Range SLIF	Model FB 7600 DELTA	T.I. Nr 04_2012
Serial Number 20311072	Subject <u>NOZZLE</u>	Complaint Nr N/A

The nozzle (SPARE **39712500**) have been modified as follows.

NOZZLE

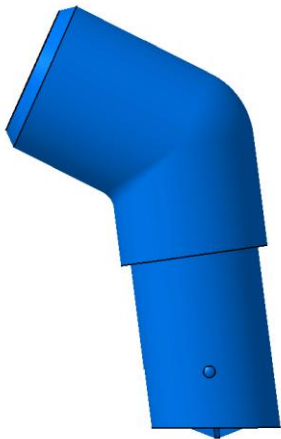
In order to improve the clamping of nozzle, has been reintroduced the previous version.

Implementation is effective starting from S/N **20311072**.
